10 th January 2022	
	<h1>Draft Assessment Report – Flood Risk</h1> <h2>Surface Water to Marlingford</h2> <h3>21-105 Easton Phase 3 and 4</h3>	
1.0 Introduction	<p>An offer of service was made by 4D Geo Ltd (4D) to the client (Easton Parish Council) for a limited scope fee proposal for ground consultancy services including a report on flood risk at a site for proposed development at Easton Phase 3 and 4.</p> <p>The proposal was accepted, and the works instructed by email.</p> <p>Only a short period of time was available for this draft report and comments are brief as a result.</p> <p>The site covers approximately 16 Hectares (ha) on the west side of the village. Development comprises residential use by Persimmon Homes and is part of a wider masterplan for the village.</p> <p>The site area is approximately maximum dimension 550m west to east and 550m south to north with approximate elevation between 43 and 38m above Ordnance Datum (maOD). The site location is shown in Figure 1 extract from https://www.openstreetmap.org.</p>  <p>Figure 1</p> <p>The site occupies land just on the south side of a topographic peak which slopes south to the River Yare at about 1.5 kilometres away at the v

Figure 15

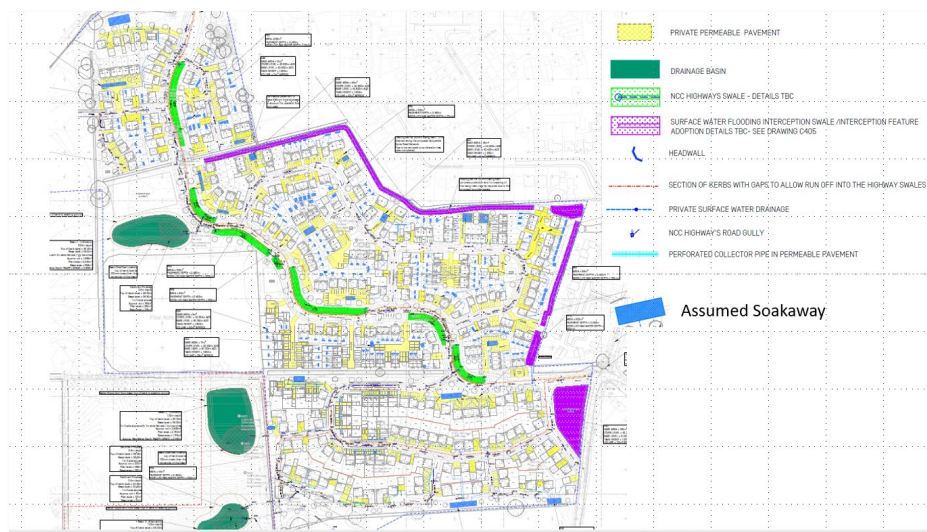
The engineering proposal drawing in Figure 15 shows how overland flows from off site would be intercepted on the north east boundary and a swale runs from north to south east. Many roofs are drained to soakaways (assumed in legend) but some are drained to basins. Permeable paving is widely used either soaking or diverted to basins. Highway drains to basins. Two basins are infiltration; north and middle. One basin (south) is attenuation.
